APPLICATION FOR AMENDMENT  
TO OPERATING LICENSING

Technical Specification  
Page Revisions

Consolidated Edison Company of New York, Inc.  
Indian Point Unit No. 2  
Docket No. 50-247  
Facility Operating License No. DPR-26  
June, 1985

I. Proposed Change To Fan Cooler Unit 23, 24, 25 Out-Of-Service Time

Figure 1

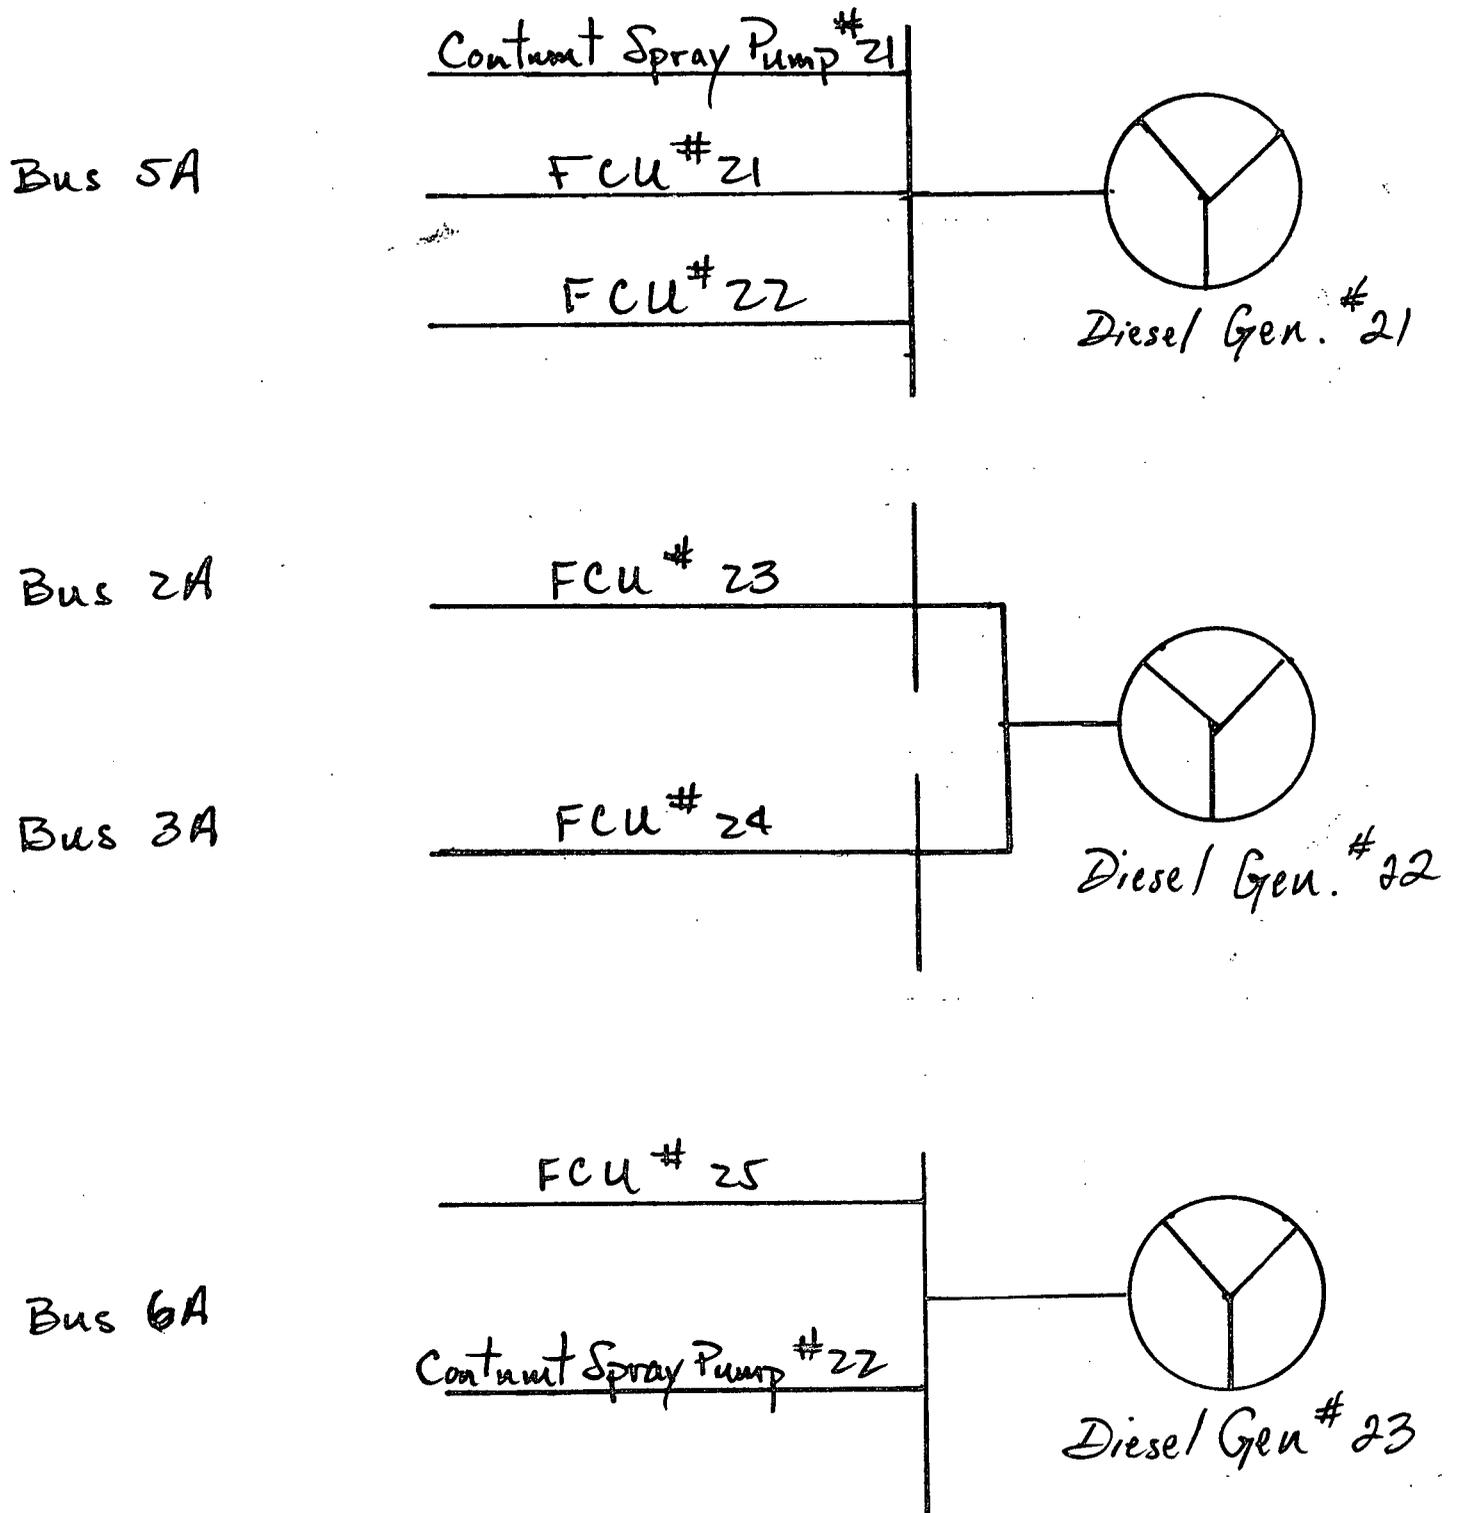
Existing Technical Specification 3.3.B.2.a limits continued power operation to either 24 hours if fan cooler 23, 24 or 25 is out of service, or 7 days if fan cooler 21 or 22 is out of service, provided the containment spray system is operable. The functional arrangement of the five fan cooler units and two containment spray pumps on the three (50% capacity) diesel generator buses establishes the basis for the differing out-of-service times. The arrangement is depicted in Figure 1.

The limiting combination of available diesels and containment heat removal equipment serves to establish the shortest allowable out-of-service times for the two groups of fan cooler units. From Figure 1, under the conditions noted above, with either fan cooler unit 23, 24 or 25 out-of-service, the failure of diesel generator 21 results in 90% remaining design heat removal capacity (2 fan cooler units and one containment spray pump) available. For any other combination of equipment out-of-service and a single diesel failure, the 100% containment heat removal capacity success criterion is satisfied by the remaining equipment. Thus with fan cooler unit 23, 24, or 25 out-of-service, a subsequent failure of diesel generator 21 results in less than 100% capability available. With fan cooler unit 21 or 22 out-of-service a subsequent single failure of any diesel generator still results in greater than 100% capability available. The limiting

case (fan cooler unit 23, 24 or 25 out-of-service) is established with the shorter allowable out-of-service time of 24 hours chosen arbitrarily, the other case (fan cooler unit 21 or 22 out-of-service) is afforded a relatively longer seven day out-of-service time. The out-of-service times selected are based on engineering judgements made in the early 1970's at the time the Technical Specifications were being developed.

A change to Technical Specification 3.3.B.2.a. to modify the 24 hour LCO for fan cooler units 23, 24 and 25 to seven days is therefore

Figure 2

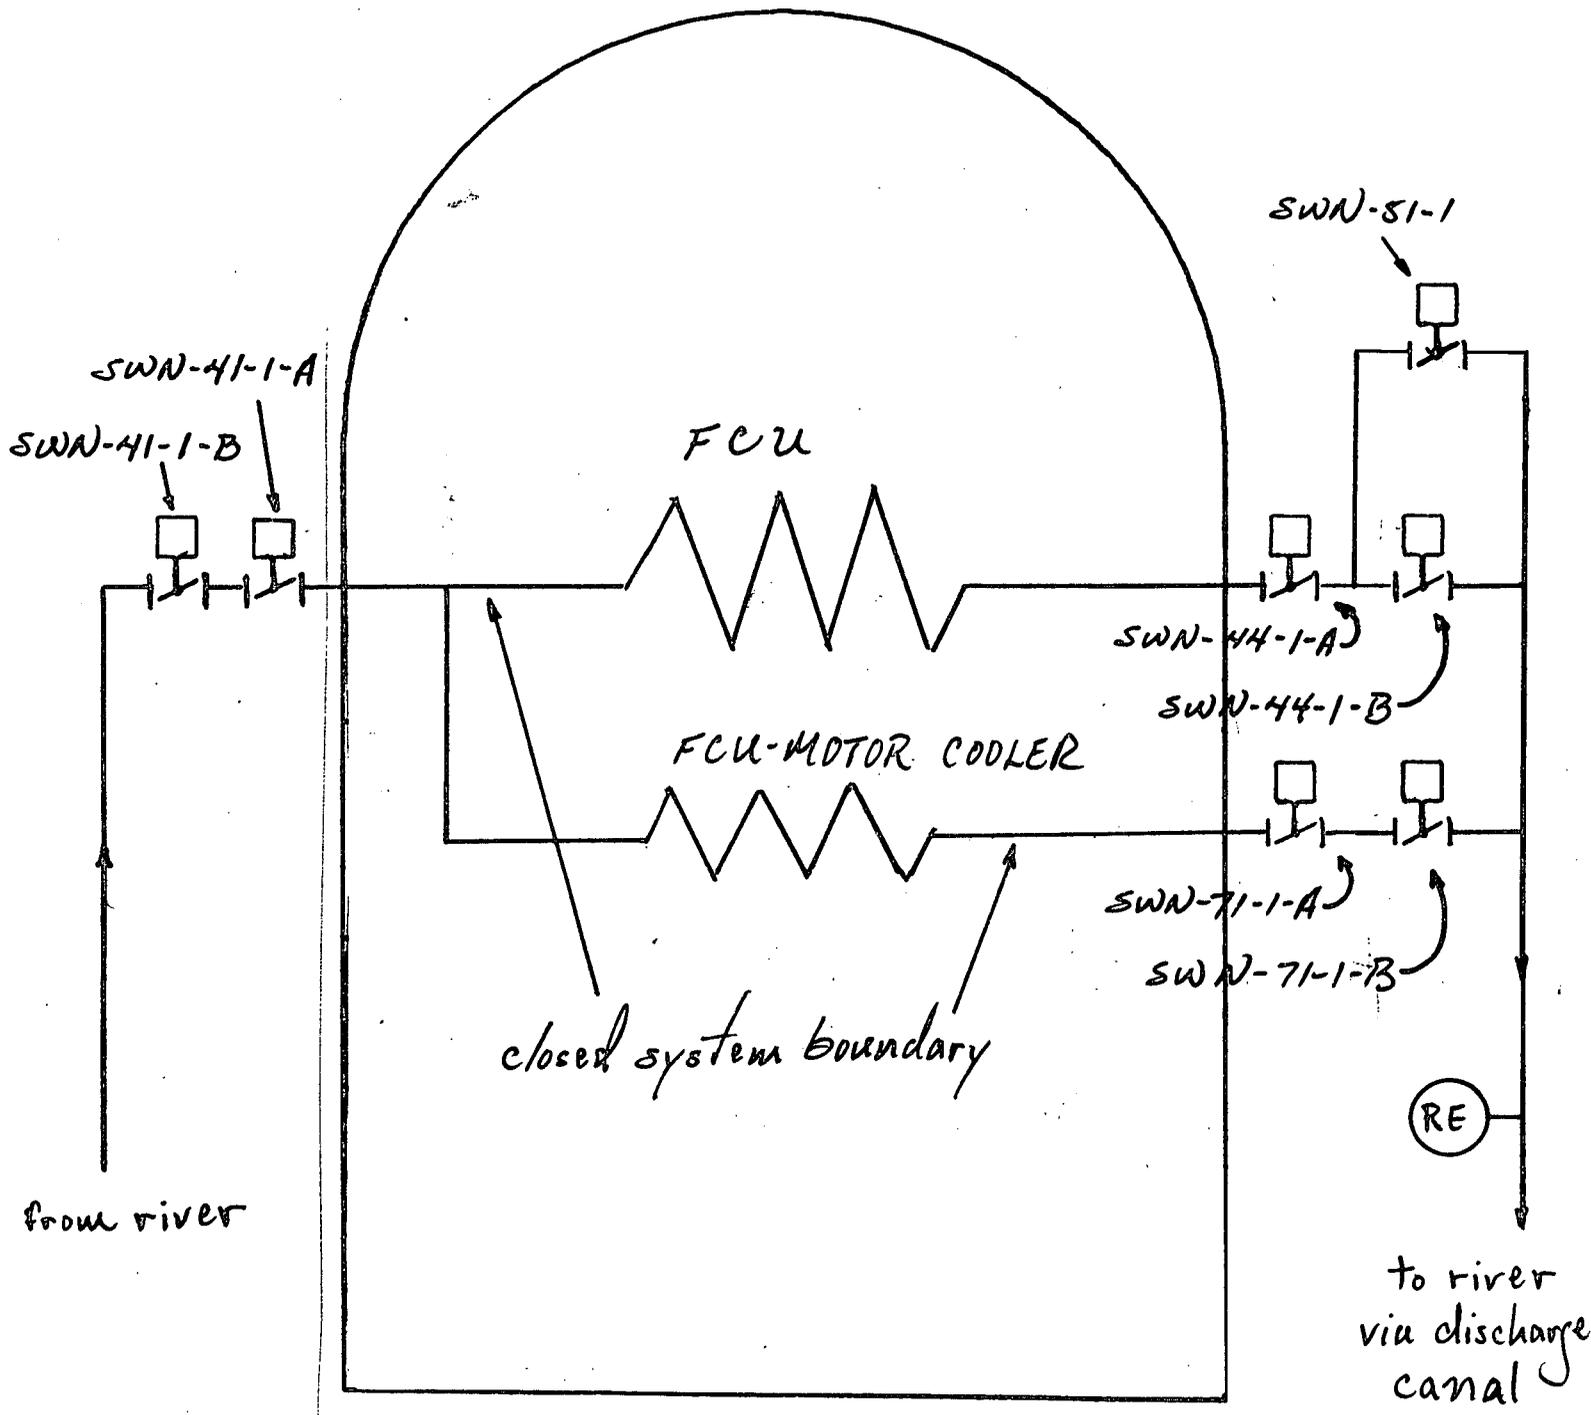
The proposed changes to Tables 3.6-1 and 4.4-1 permit the use of existing installed back-up valving in the service water supply and return lines associated with the FCU's as alternate containment isolation valves when so designated by plant management. The purpose

of this change is to permit greater operational flexibility for complying with containment isolation requirements and effecting isolation of fan coolers, if required.

By design, double boundary containment isolation requirements for these lines are satisfied by the closed system boundary inside containment and a containment isolation valve outside containment. Figure 2 depicts these provisions for a single fan cooler unit. In the event that a containment isolation valve becomes inoperable, this proposed change would permit redesignating the alternate containment isolation valve as the "required" containment isolation valve in that line, provided the surveillance requirements for the alternate valve have been satisfied. The existing installed back-up valves are the same type and manufacture as the valves currently designated as containment isolation valves.

The Commission has provided criteria for determining whether a proposed amendment to an operating license involves no significant hazards considerations, 10 CFR 50.92 (48FR14871). The proposed changes to Table 3.6-1 would permit redesignating installed back-up valves in the fan cooler unit service water supply and return lines as containment isolation valves when necessary to satisfy containment isolation requirements. The proposed changes to Table 4.4-1 add the installed back-up valves to the list of containment isolation valves subject to

surveillance requirements. Accordingly, redesignation of an alternate valve(s) as a required containment isolation valve(s) is contingent upon the alternate valve(s) having satisfied the surveillance requirements.
